Town of Parker Community Development Department
Development Review Division
Attention: **Amber Wood Hicken**

Application Type: **Site Plan – Non-Residential**
Status: **First Referral**
Application Name: Parker & Pine F1 L1 - In-n-Out Burger
Case/AP#: **SUB22-063**
Referral Received: February 8, 2023
Comments Due: March 8, 2023

Review date: **February 28, 2023**
Plan reviewer: **Randall L. Capra**, rcapra@parkeronline.org
Phone: 303.805.3163

TOWN OF PARKER - FIRE/LIFE SAFETY:	R REVIEWED FOR CODE COMPLIANCE; REVISIONS REQUIRED
---	---

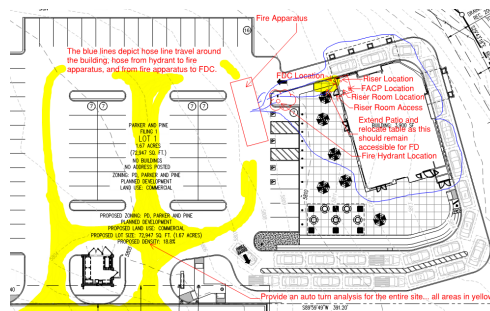
4. Per the requirements of [21 IFC Section 503.1.1 Buildings and Facilities] approved fire apparatus access roads shall be provided for every facility, building, portion of a building hereafter constructed or moved into or within the jurisdiction. The fire apparatus access road shall comply with the requirements of this section and shall extend to within 150 feet of all portions of the facility and all portions of the exterior walls of the first story of the building as measured by an approved route around the exterior of the building or facility (the building, as approximately 4,000

sf (or 40'x 100') cannot meet the requirement as measured from the center line of the fire apparatus as measured by an approved route from any point that a fire engine might park when responding to a call at this building).

Per the requirements of the code, the fire code official is allowed to increase the dimension of the 150 feet provided that the applicant meets Exception 1.1 of this section... "The building is equipped throughout with an approved automatic sprinkler suppression system installed in accordance with section 903.1.1, 903.1.2, or 903.3.1.3; a sprinkler suppression system will be required. The building is to be sprinklered per pre-application meeting discussions. *Note – This issue was satisfied by the applicant when reviewed through the SP21-126 submittal process.*

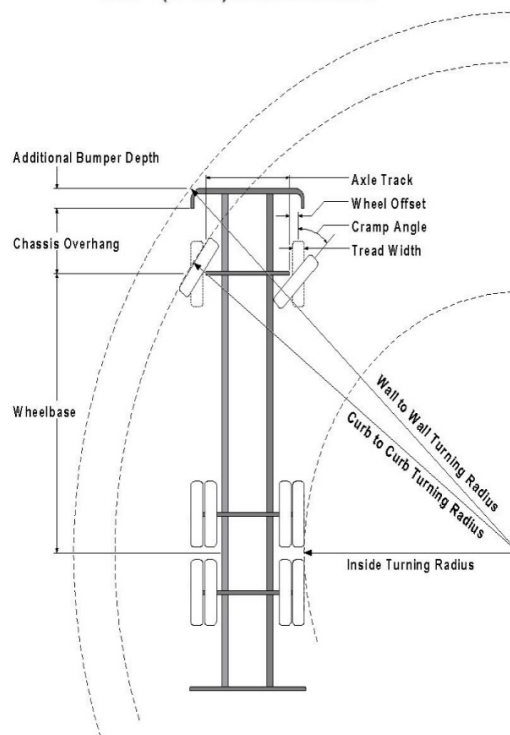
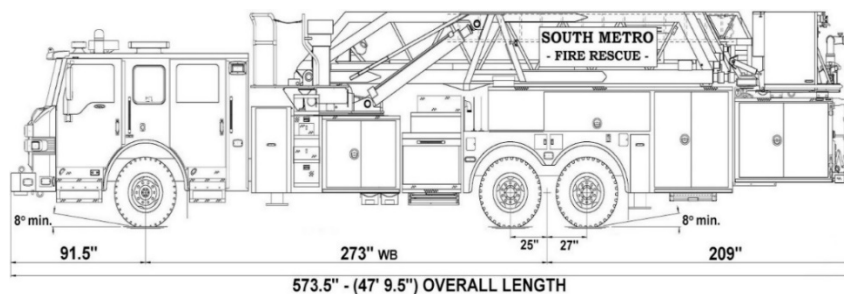
8. The Town of Parker requires that fire apparatus access roads meet the clear-width and weight-bearing standards of the jurisdiction in which the project is located. Roadways shall be designed to support the imposed weight of fire apparatus, 30-ton, two axle and 40-ton three, axle vehicles. An unimpeded clear width of 20-feet shall be maintained at all times (though Planning and Zoning requirements may require a minimum of 24 feet). Where building exceed 30 feet in height, a fire department access is required to be 26 feet in width. As such, any location where parked vehicles would obstruct this clear width requirement will require "NO PARKING – FIRE LANE" signage. *This signage shall be red on white. Update design criteria has been provided at the end of this document; ensure compliance when resubmitting.*

The applicant shall provide an auto turn analysis indicating that apparatus can navigate all portions of this site (both sides of the gas canopy); NO PARKING – FIRE LANE signage is required for any portion of the access where the 20-foot clear width requirement cannot be met. *Note – This issue was being addressed by the applicant when reviewed through the SP21-126 submittal process; as this issue was not fully addressed at the time, this submittal should have included the auto-turn analysis that was prepared for SP21-126. Address this issue when resubmitting. The area shown in yellow indicates what was previously required in this analysis.*
